**Re: Planning Proposal
61 – 73 Christie Street, St Marys**

I have considered the issues raised in Council's email of 27.10.15 and respond in the following:

**SWEPT PATH ANALYSIS
OF A 19m ARTICULATED
VEHICLE ENTERING AND
EXITING THE SITE**

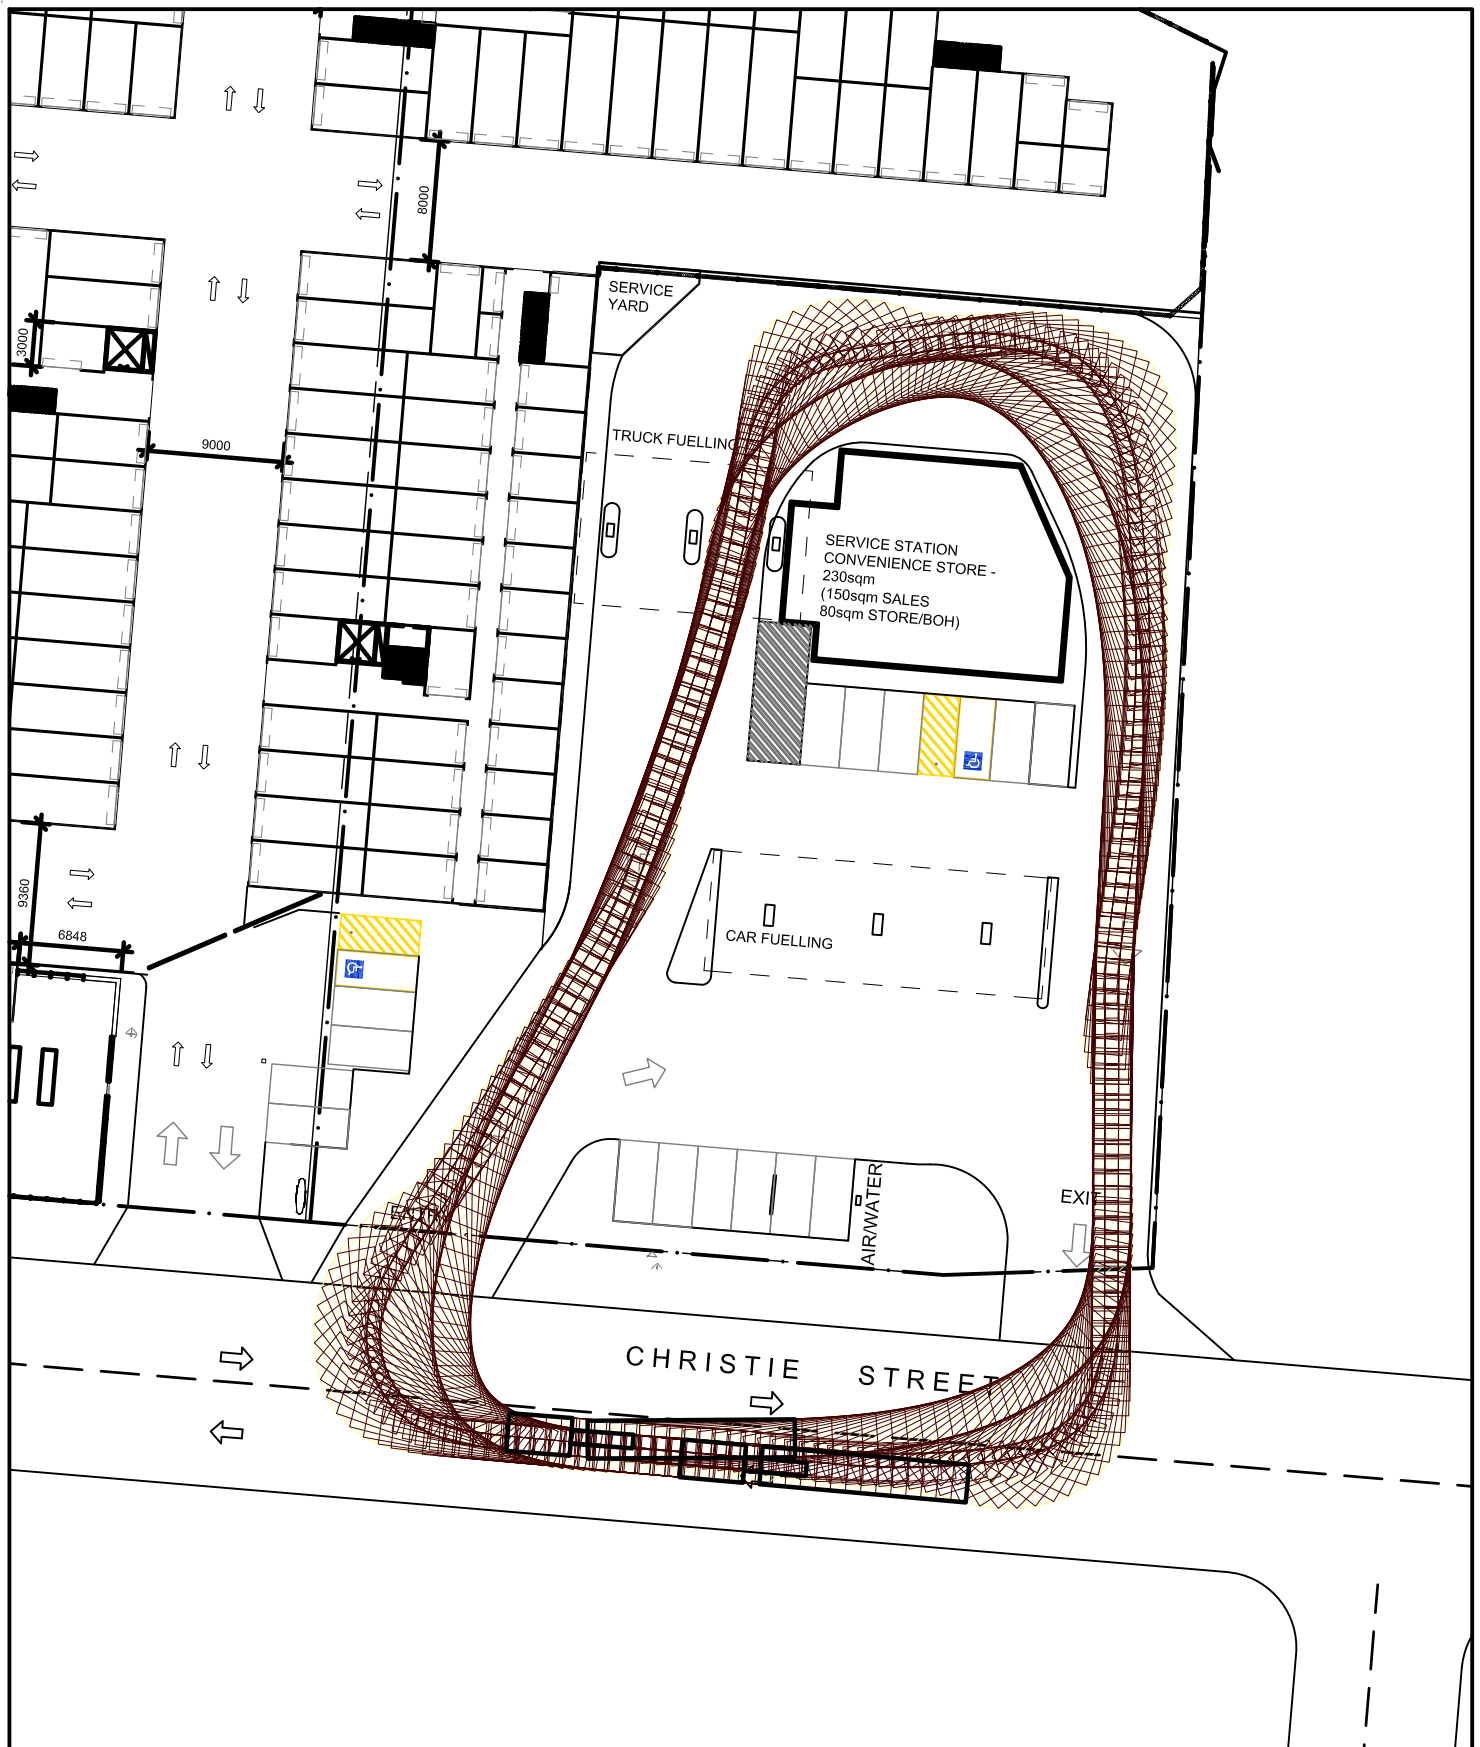
*** Turning Paths**

The requested diagrams are attached indicating satisfactory turning provision for fuel delivery vehicles.
